ADDENDUM NO. 1 DATED 5/19/2016 ADDENDUM NO. DATED
 ADDENDUM NO. DATED ADDENDUM NO. DATED

STP/EXB-2920-00(014) / 105335301 & 302

**MISSISSIPPI DEPARTMENT OF TRANSPORTATION
TABLE OF CONTENTS**

**PROJECT: STP/EXB-2920-00(014)/105335301 - Tate
STP/EXB-2920-00(014)/105335302 - Desoto**

WORKING NUMBER	EQ-2
SHEET NUMBER	14

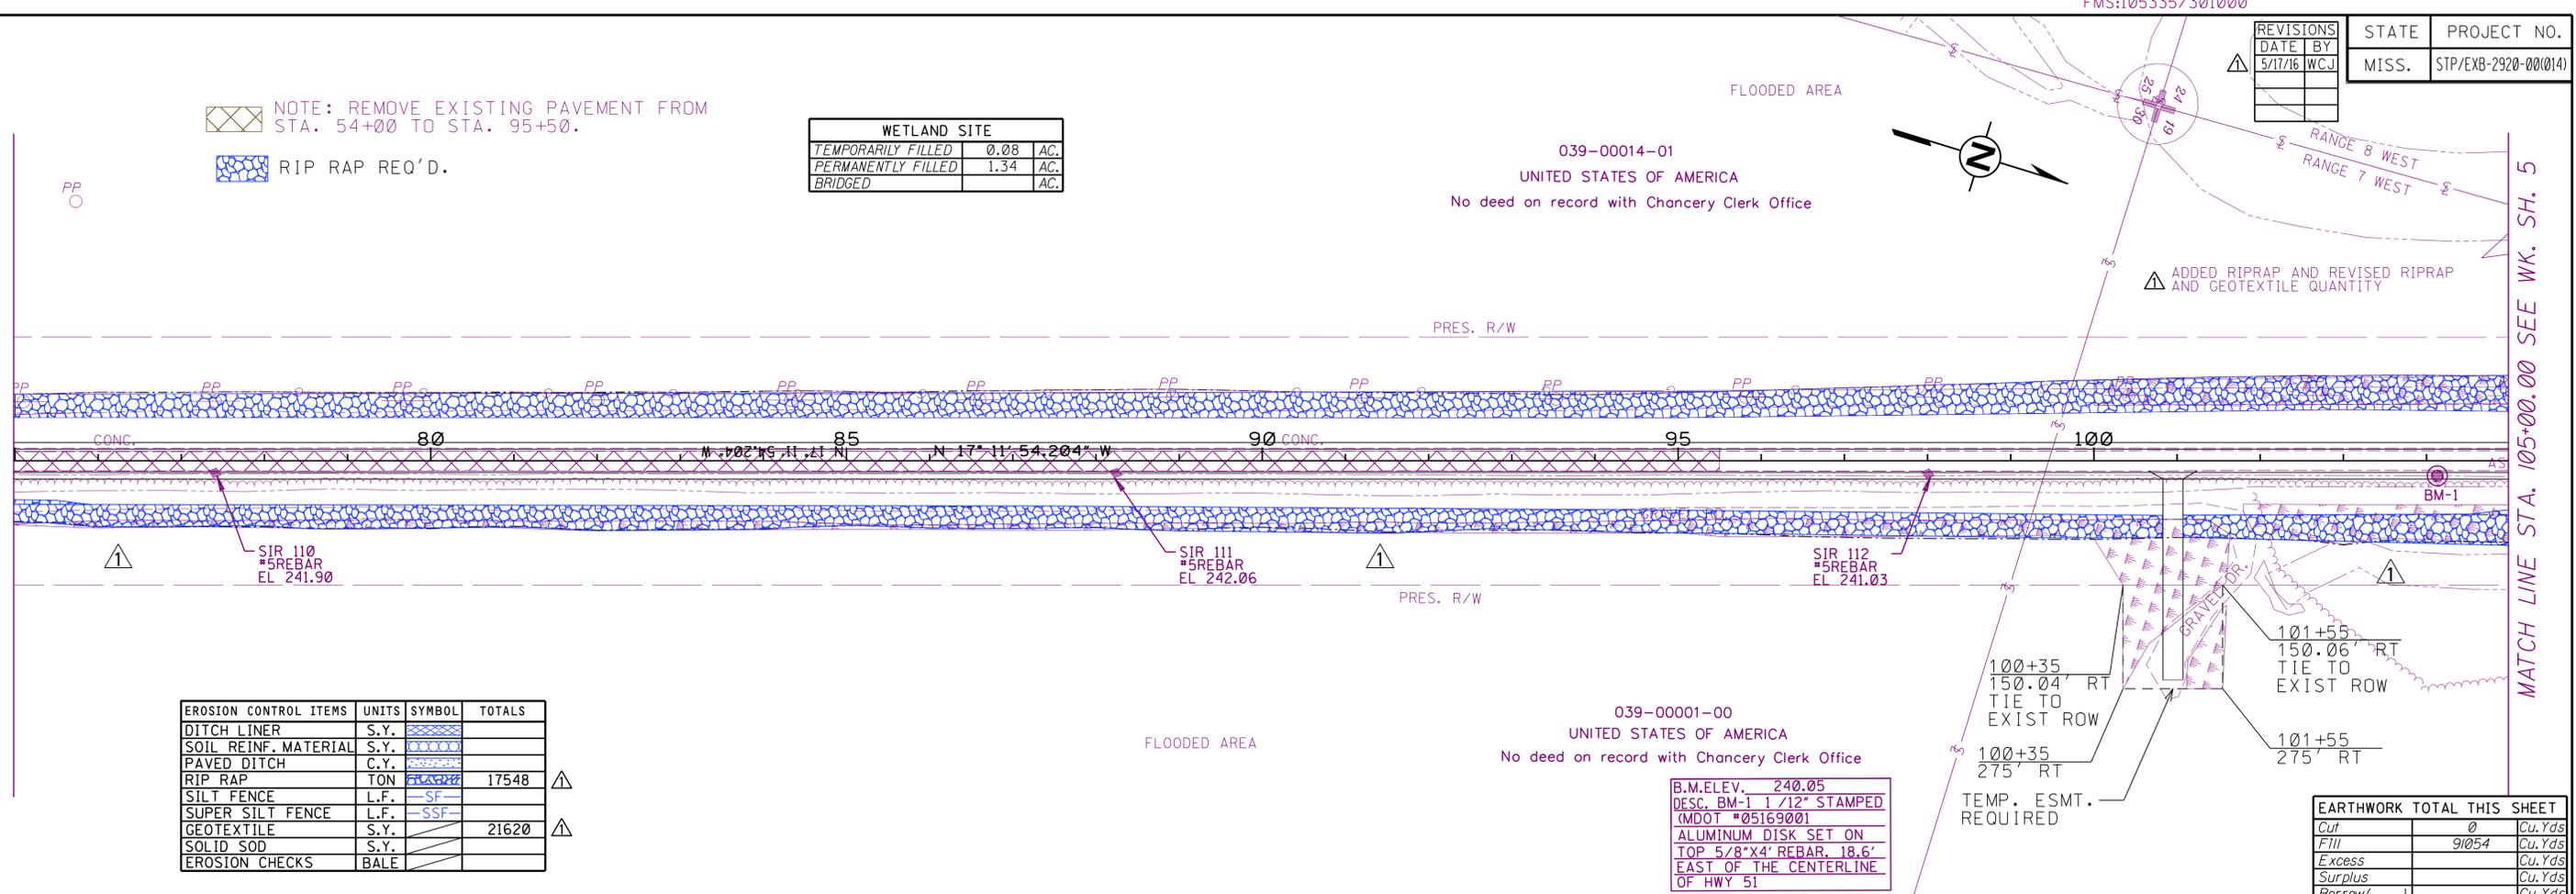
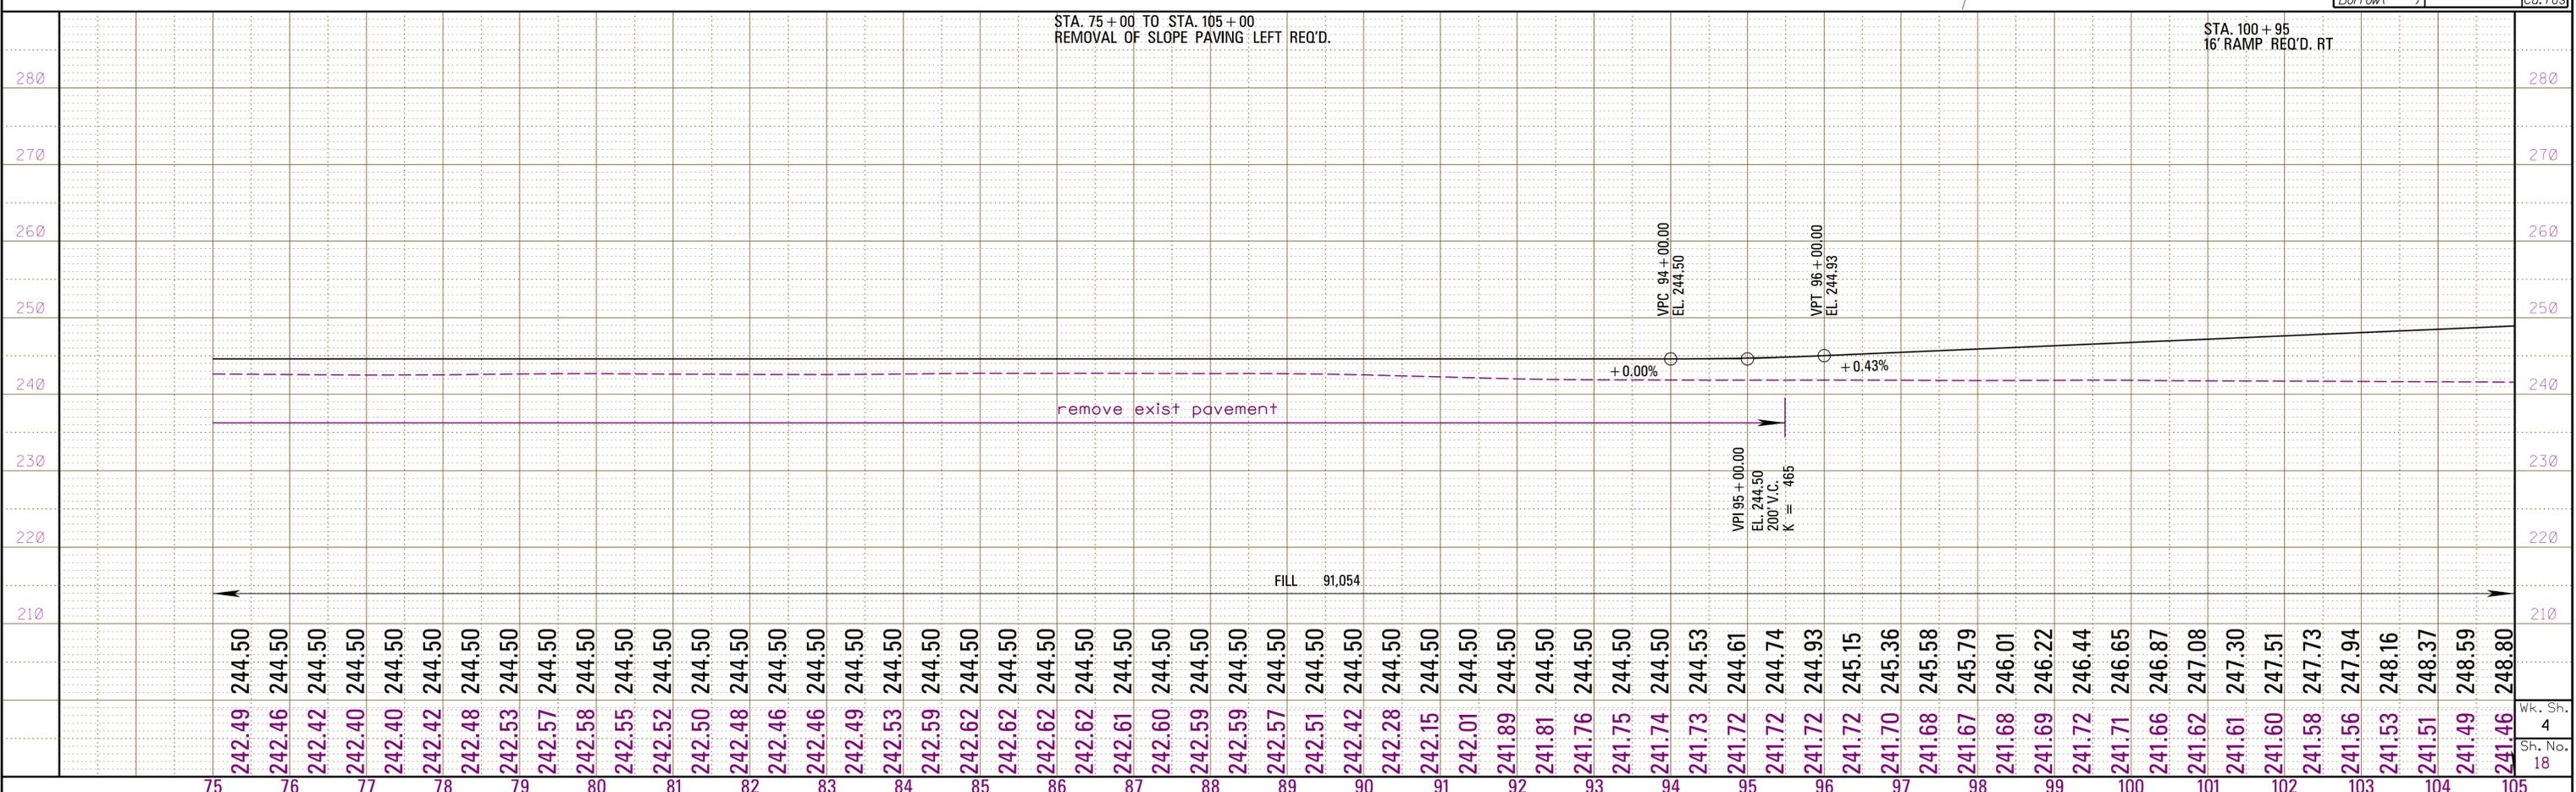
5-17-16	REVISED SILT FENCE QUANTITY	DATE	BY
